**CITY OF BEVERLY
ADDENDUM NO. 1, March 20, 2015**

**RE: INVITATION FOR BID
15-1000 Lynch Park Bathroom Building**

This addendum forms a part of the Invitation for Bids from the City of Beverly for:
15-1000 Lynch Park Bathroom Building

TRENCH DETAIL FOR SEWER AND DRAIN PIPES

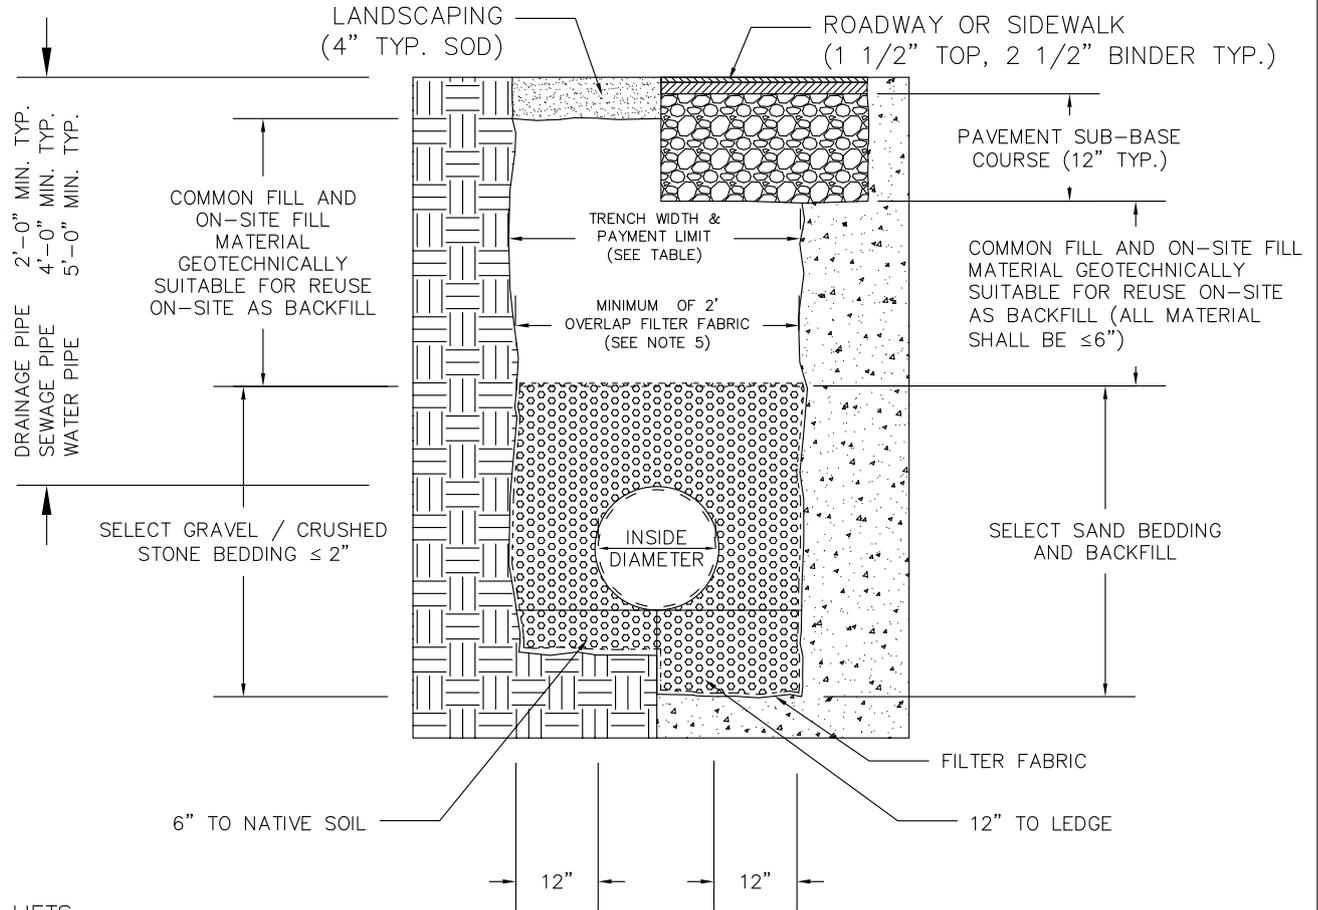
Question: Could you provide a see trough section of utility trench?

Answer: Yes, trough section of utility trench attached to this addendum.

BACKFILL MATERIAL TO BE PLACED IN 4" LIFTS IF COMPACTED BY HAND AND 12" LIFTS IF COMPACTED BY MACHINERY. COMPACT TO 95% STANDARD PROCTOR OR 92% PROCTOR
